Drinking Water Audit Report

County:	Wexford	Date of Audit:	7 th July 2017
Plant(s) visited:	Camolin Water Treatment Plant (3300PUB1779)	Date of issue of Audit Report:	11 th July 2017
		File Reference:	DW2017/91
		Auditors:	Mr. Darragh Page
Audit Criteria:	<ul style="list-style-type: none"> • The <i>European Union (Drinking Water) Regulations 2014 (S.I. 122 of 2014)</i>. • <i>The EPA Handbook on the Implementation of the Regulations for Water Services Authorities for Public Water Supplies (ISBN: 978-1-84095-349-7)</i> • The recommendations specified in the <i>EPA Drinking Water Report</i>. • EPA Drinking Water Advice Notes No.s 1 to 15. • The recommendations in any previous audit reports.

Photo 1. Schematic of the Camolin Water Treatment Plant.

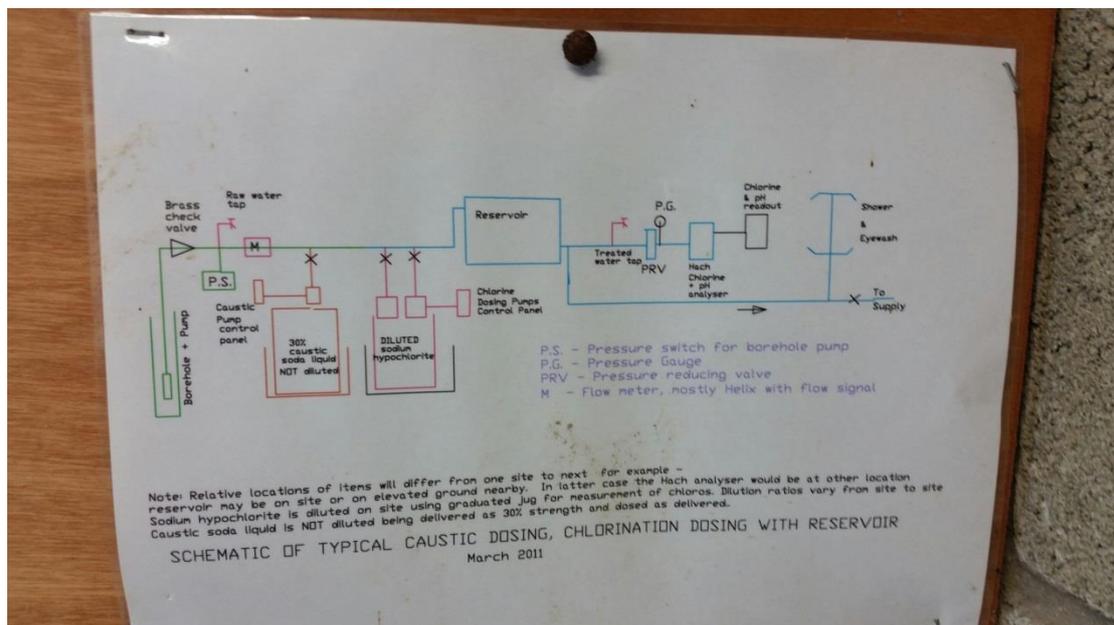
1. Irish Water should review the schematic of Camolin water treatment plant and ensure that it represents the correct sequence of treatment processes at the plant.
